# Product Change Notification

**Product Change Notification:** PCN-22-159284

CONTACT, RECEPTACLE, CRIMP SNAP-IN, MICRO MATE-N-LOK

**Description of Changes**

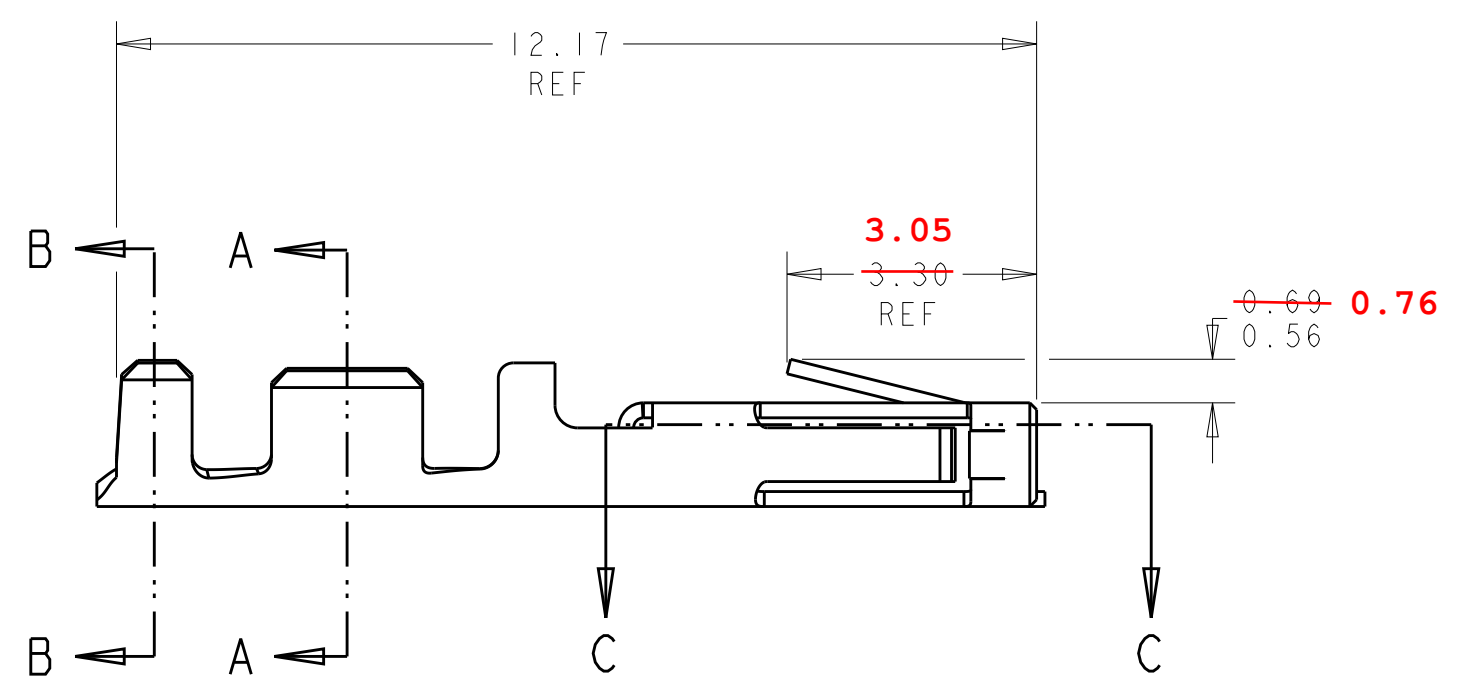
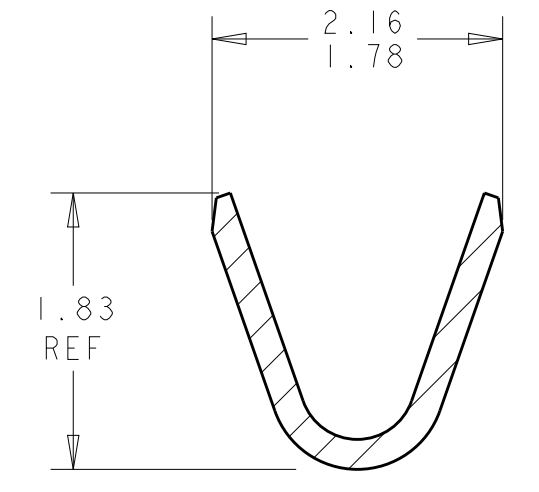
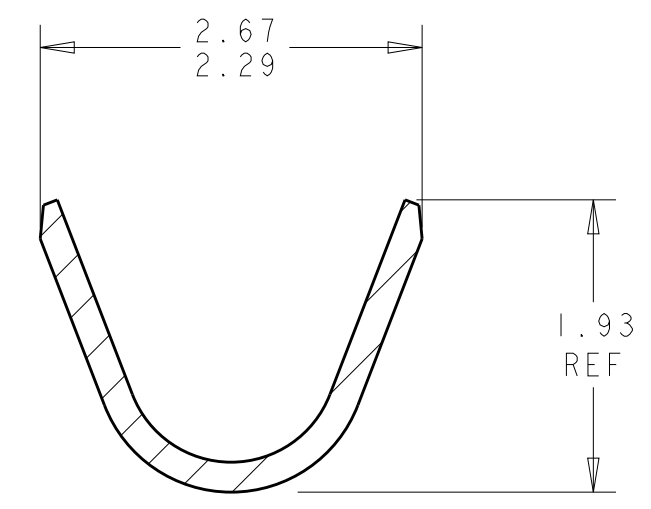
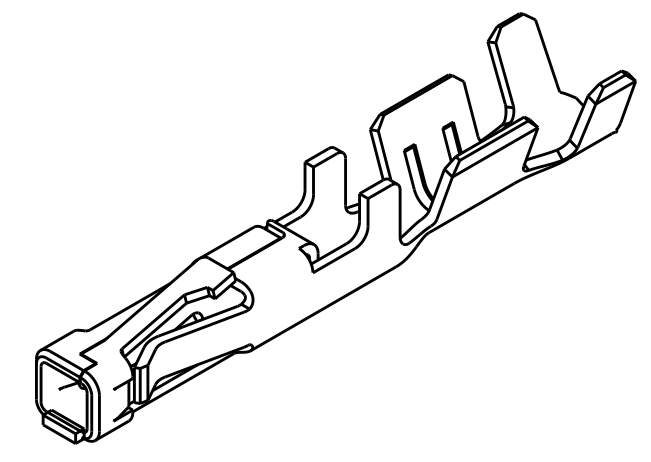
There are some dimensions in the loose piece customer drawings divergent from strip customer and production drawings. We are correcting those dimensions since loose-piece terminals are made from strip terminals!

There are some dimensions tolerance in customer drawing in disagreement with what is specified in our production drawing. Then, we are correcting to avoid issues in future! This does not affect product functional because our products follow production drawings and it has been provided for a long time in this way!
